Limerick D3 Analysis Evaluation Open Item Summary Table

Figure 1 - Existing LGS Reactor Mode Switch and RPS Manual Scram Circuitry

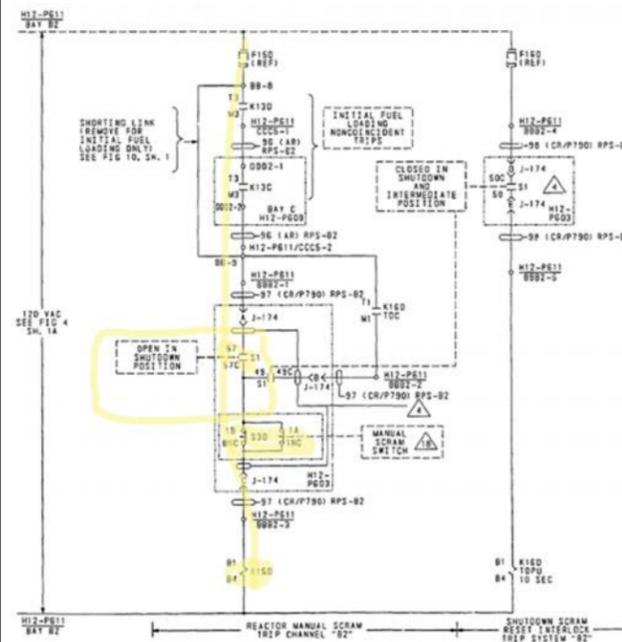
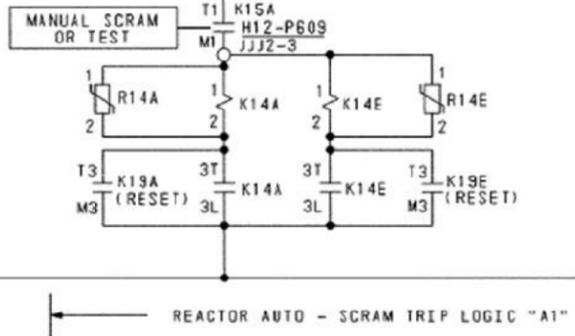
Mode Selector Switch: The mode selector switch input to the PPS is shown as an input to the Local Coincidence Logic module in each division of the PPS. This indicates that the reactor scram function of the Mode Selector Switch may be dependent on PPS functionality to initiate a reactor scram.

6/1/22: The UFSAR only refers to the Mode selector switch scram function as a backup to the RPS manual controls (see Section 7.2.2.1.2.3.1.17, "RPS – IEEE 279 (1971), Paragraph 4.17"; not a diverse backup. Therefore, there is no reduction in diversity. As shown in Figure 1, the existing LGS configuration of the Mode Selector Switch and the RPS manual actuation logic share a significant amount of circuitry that feeds into the final actuation circuitry. Although the Reactor Mode Switch is a separate input into the scram circuit, it is not a diverse scram signal. [REDACTED]

[REDACTED] there is also the PPS Manual Scram (reactor scram push buttons) that interfaces directly to the RPS TUs, bypassing all PPS software as discussed in section 2.1.
